Access Compliance Report Public Rights-of-Way (Curb Ramps)

Main Street: RAINBOW_DR		Cross Street: RAINBOW_DR		Location:	NE
ADA ID: RPAT211008103421	Ramp Type:Type 1 - Perpendicular Diagonal Initial Pass/Fail: Fail		Overall Compliance: No	Severity Score:	2
Codes/Mitigation Info/Possible Solution			Field Measurements/Component Compliance

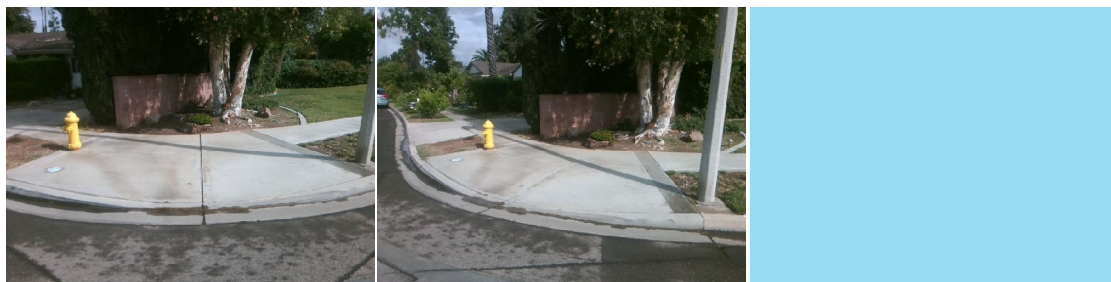
R304.2.2, R304.5.3, STD 1115

Remove & Replace Curb Ramp With Two New Directional Ramps or Equivalent.
